LOCAL HISTORIC DISTRICT: Dilworth

PROPERTY ADDRESS: 2114 Dilworth Road East

SUMMARY OF REQUEST: Front Door/Painted Brick

APPLICANT/OWNER: Amanda Gray, applicant

New fireplace off back of house

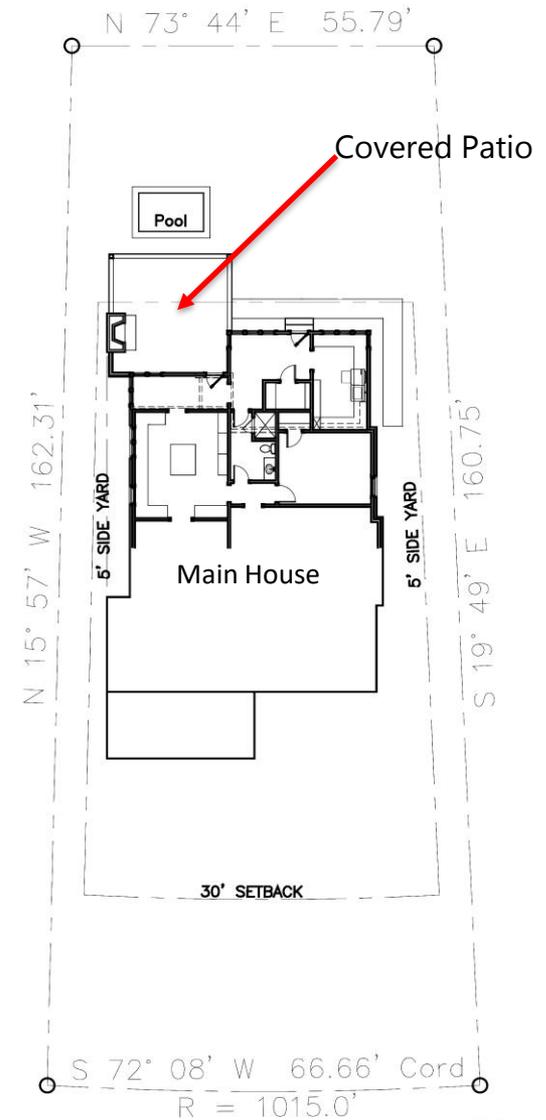
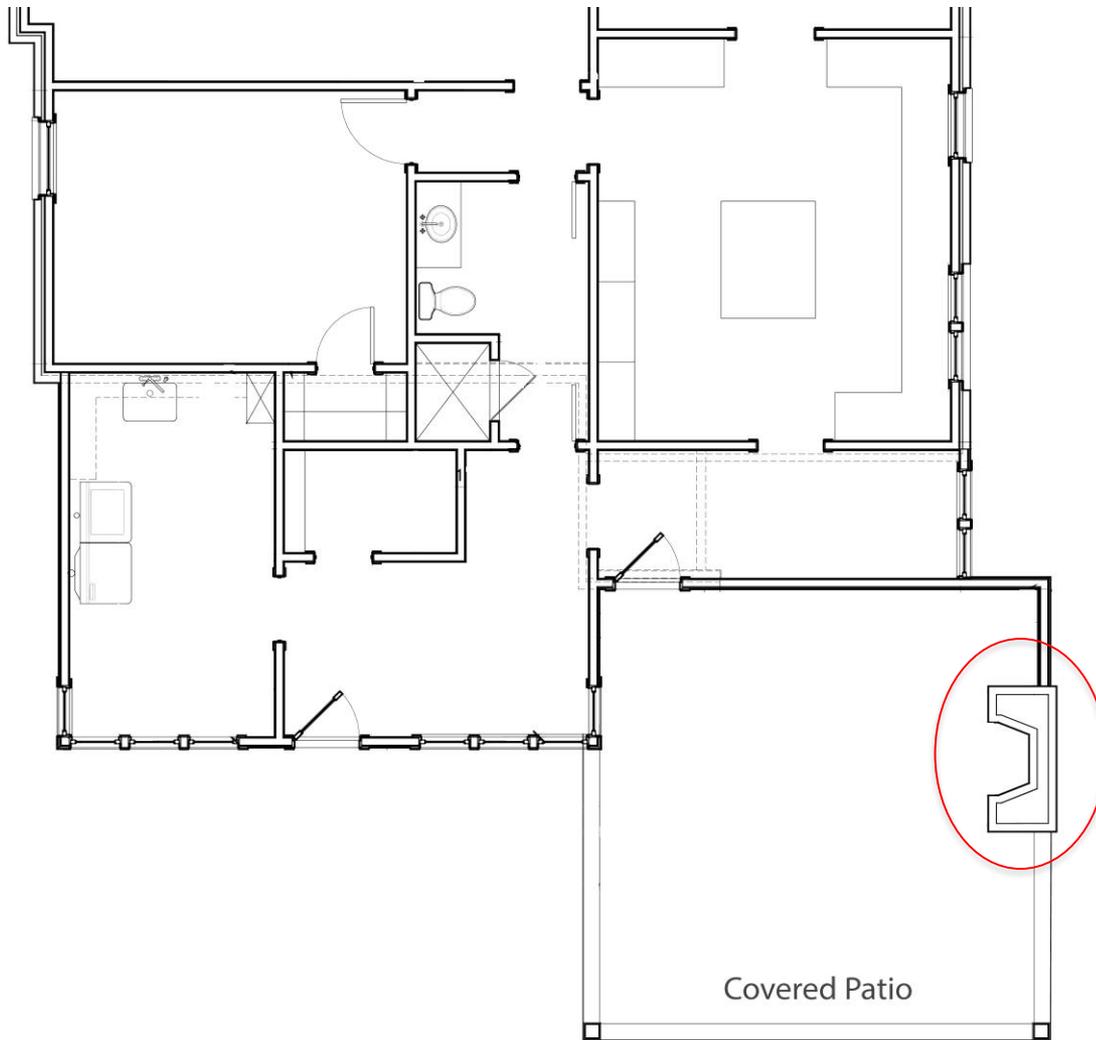
1. Guidelines for Masonry, 5.5 item 3, and Paint 5.8, item 7, require unpainted brick to remain unpainted; however, the reference is to historic masonry. The guidelines are silent on whether or not new brick can be painted, only referencing brick as a traditional material appropriate for new construction in Materials, 6.15, item 1.

Therefore, the Commission will make a determination if new addition of an outdoor fireplace/chimney element may be painted to coordinate with the painted brick house as previously approved by the Commission in 2015 under the old guidelines.

Request to paint new brick fireplace to match existing brick painted house.

Painting the fireplace will allow it to blend in and match existing house:

Conditions of current doors,
interior side...

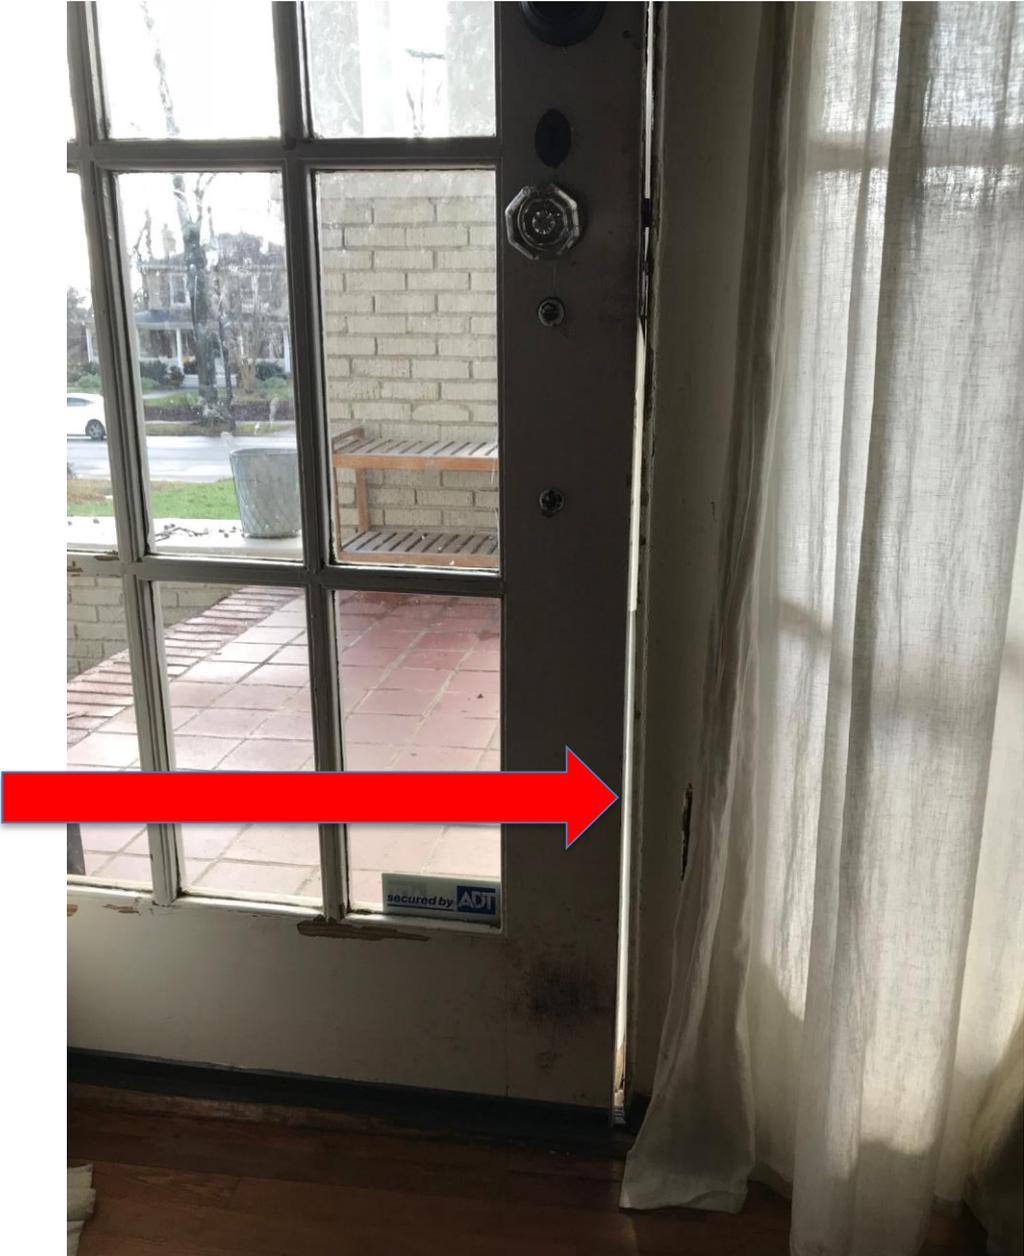
Request to replace damaged doors that have inoperable and irreplaceable hardware.

Large gap

Large gap

Large gap

½ inch gap

**Multiple areas
where wood has
splintered, especially
on the bottom. Had
some previous rot.**

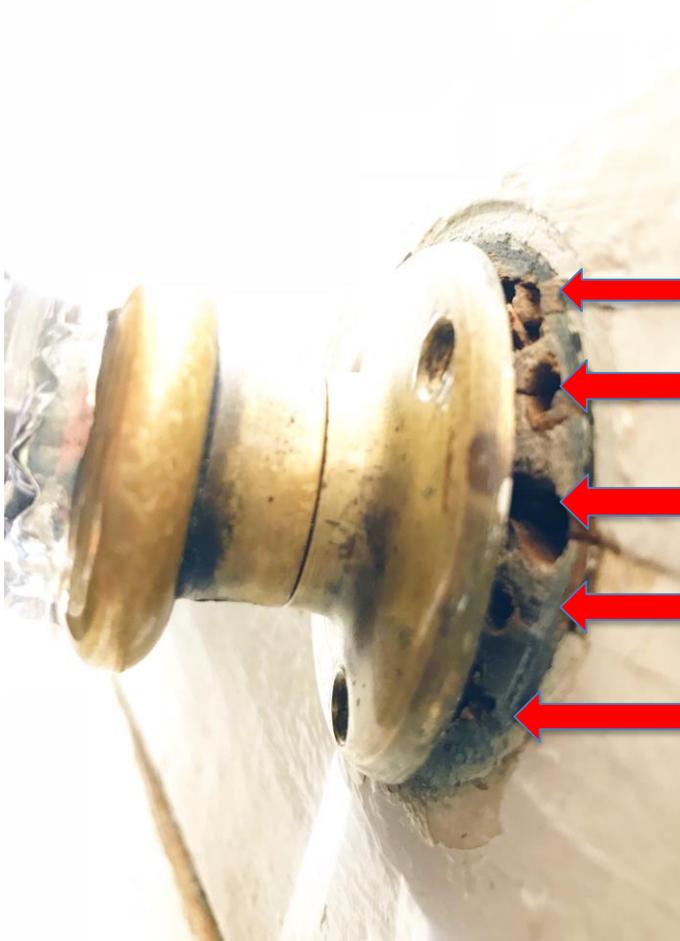
Operable stationary door lock. While this works, the door itself moves back and forth an inch in each direction.

Inoperable stationary door lock. This door does not lock into place as it does not have all of it's parts. A big safety concern.

Wood is completely worn out around the entire knob. Locksmiths say our only option is to replace our doors or install a new knob set above our current set. This is not a practical option as it would be too high to comfortably operate and unreachable for our children. All around, it just would not be aesthetically pleasing.
